Wisconsin Department of Transportation

Proposal #07: 4492-03-71, WISC 2020 384
Racine Street Bridge, C of Menasha;
Fox River Bridge and Approaches
Local Str
Winnebago County

Letting of August 11, 2020

This is Addendum No. 02, which provides for the following:

Addendum No. 02
ID 4992-03-71
Revised Sheet 26
August 4, 2020

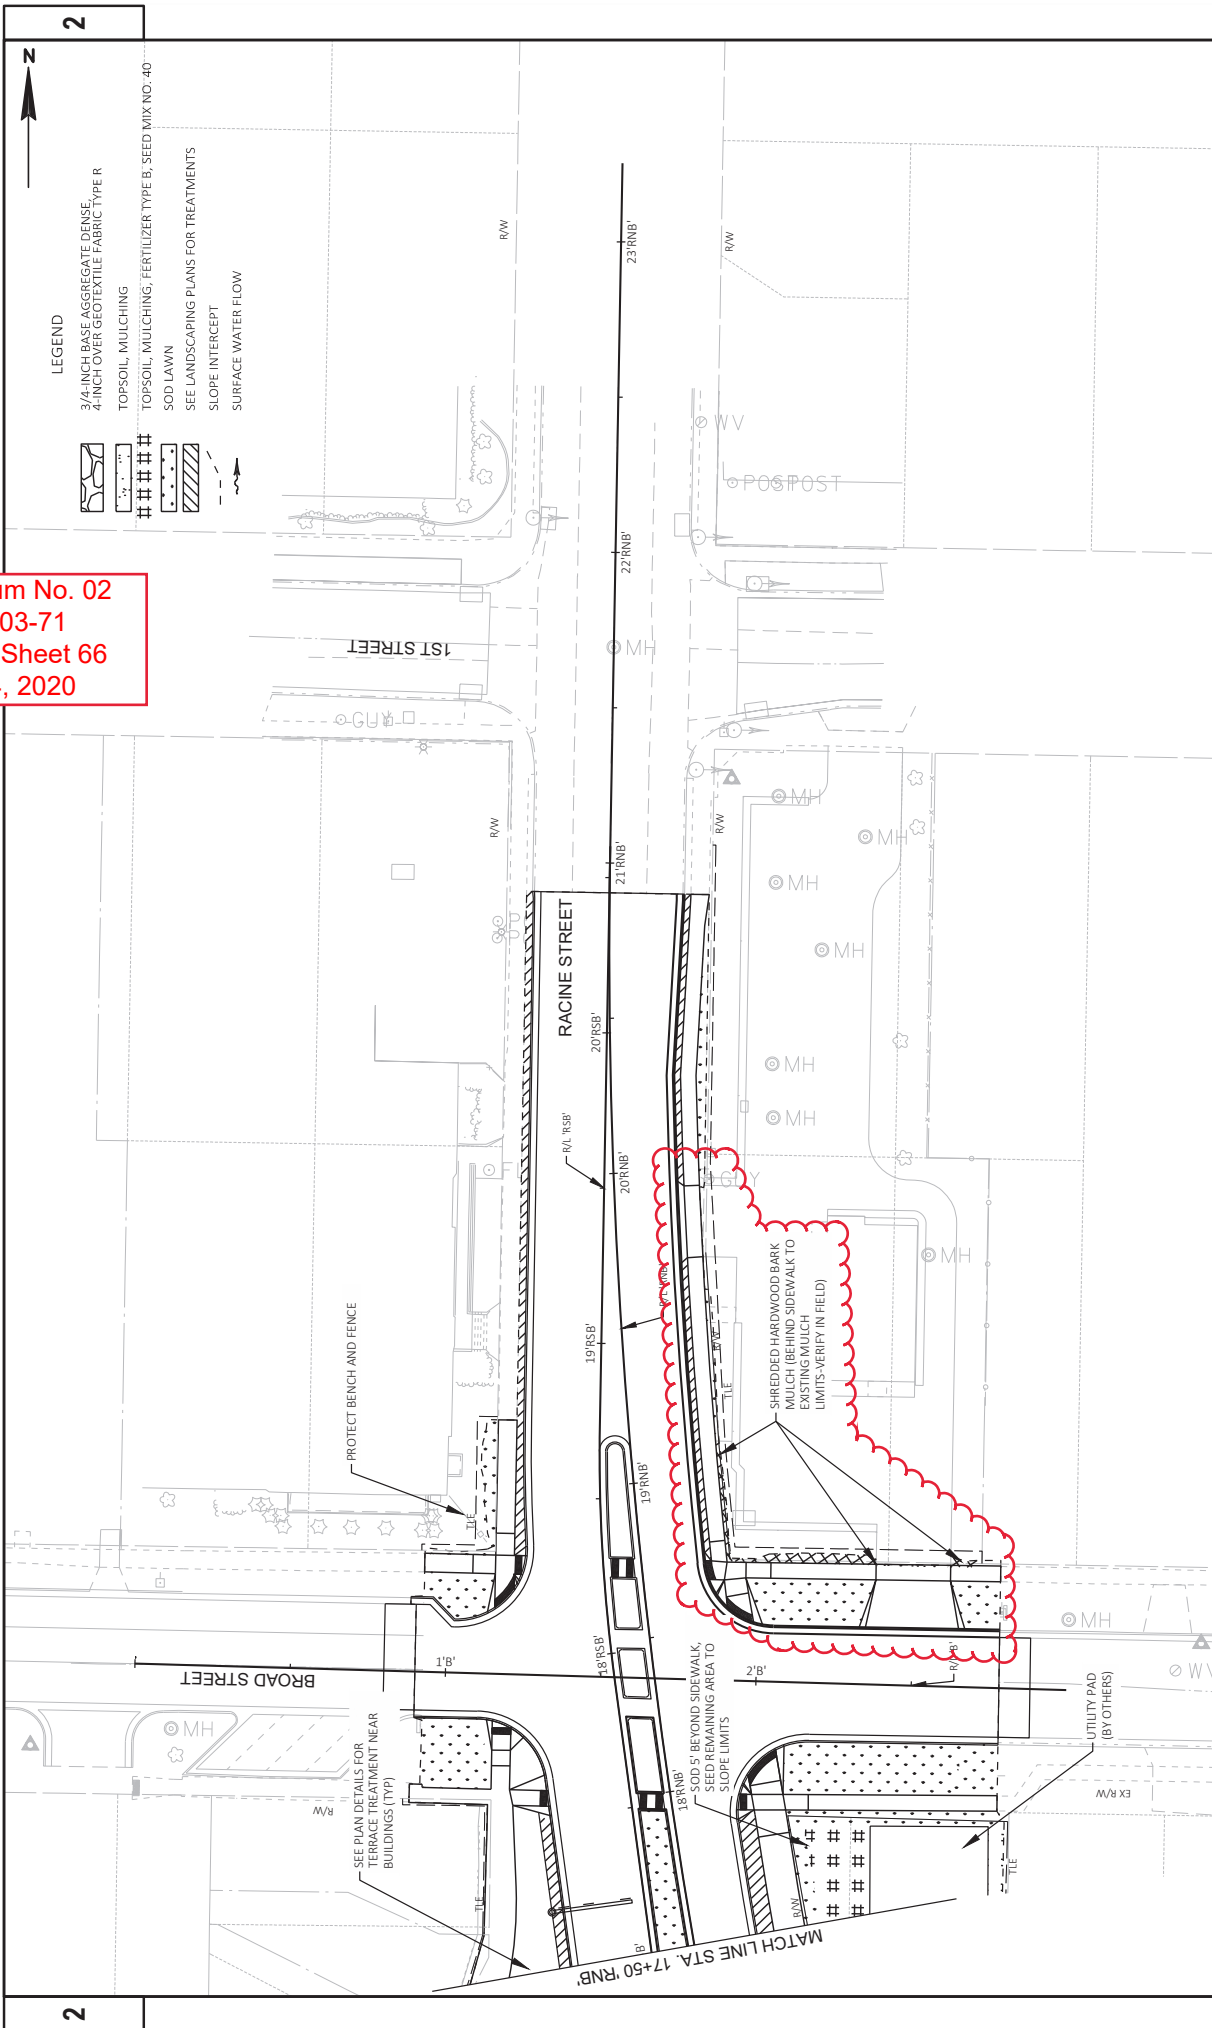
Revised Plan Sheets	
Plan Sheet	Plan Sheet Title (brief description of changes to sheet)
26	Plan Details (Driveway widths and existing topography)
34	Storm Sewer Removal Plan (Additional removal for new pipe location)
50	Paving Grades (Driveway jointing update)
66	Erosion Control – Permanent (Updated sod and mulch for driveway changes)
70	Storm Sewer (Revised pipe at Broad Street intersection)
134	Miscellaneous Quantities (Revised storm sewer removal quantity)
136	Miscellaneous Quantities (Revised asphaltic surface for peninsula, revised driveway, sidewalk, base for Broad and Racine Street intersection NE quadrant)
137	Miscellaneous Quantities (Added storm sewer SPV)
141	Miscellaneous Quantities (Revised topsoil, fertilizer, sod, water, and mulch quantities)
151	Miscellaneous Quantities (Removed Management of Petroleum Contaminated Water item)
164	Plan and Profile: Racine Street Northbound (Revised utility and topography base files, proposed driveways)
